From: Donna Gilmore <donnagilmore@gmail.com>
Sent: Thursday, January 26, 2017 1:18 PM
To: Griffith, Andrew
Subject: DOE Pilot comments & Response to RFI on Private Initiatives to Develop Consolidated SNF Storage Facilities

RE: Response to IPC – DOE's CIS Nuclear Waste Plan Risks Major Radioactive Leaks

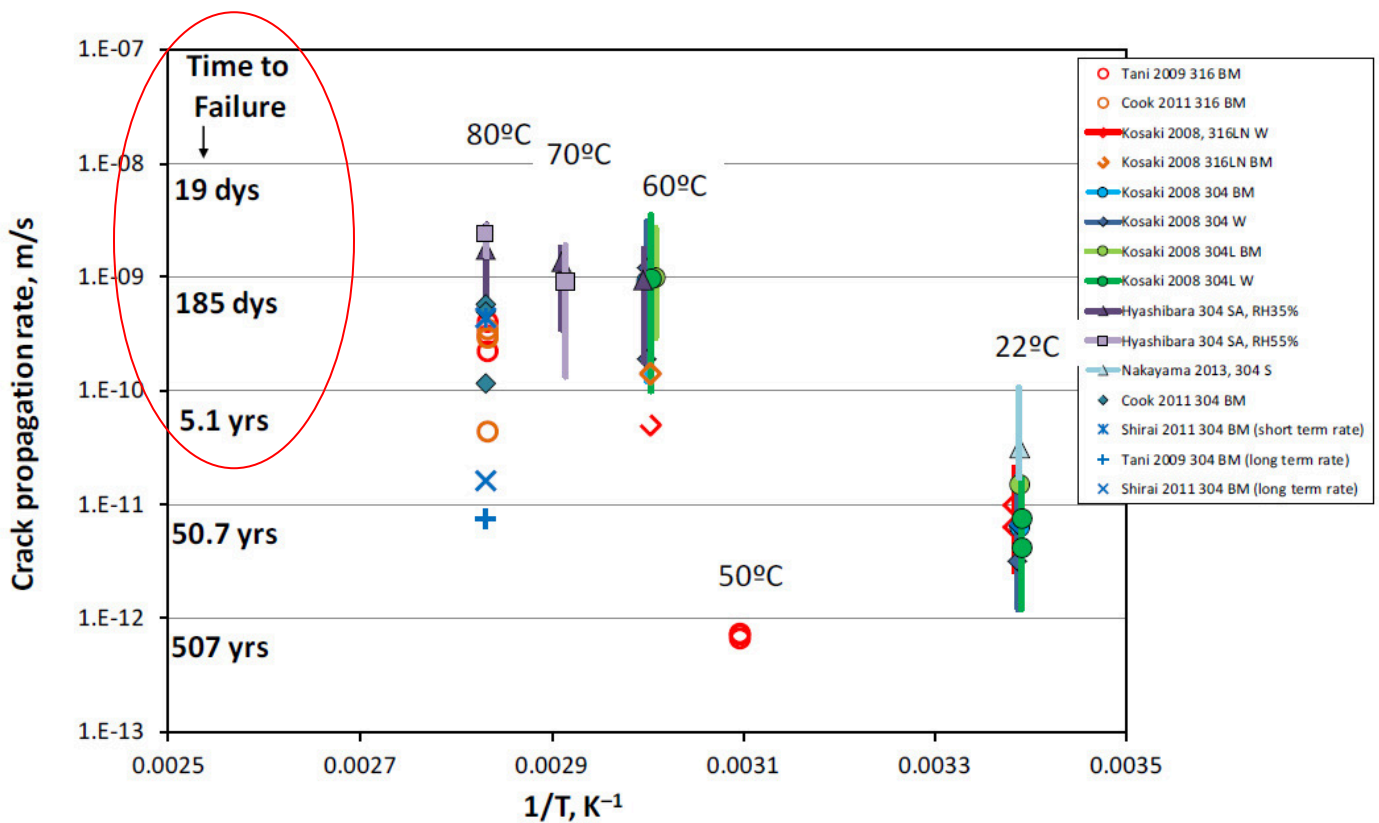
Thin-walled stainless steel U.S. irradiated spent fuel storage canisters at higher temperatures will have faster crack growth rate. The Sandia Chart below shows higher temperatures can cause canisters to penetrate the wall in less than 5 years. This chart assumes canister wall is 0.625” (5/8”) thick. The majority of the U.S. canisters are only 0.50” (1/2”) thick. It is unknown when a crack will start, but these canisters are subject to corrosion and cracking from environmental conditions such as chloride salts, air pollution (sulfides), pitting, and microscopic scratches. The report states that canisters such as those at Diablo Canyon have temperatures in these heat ranges.
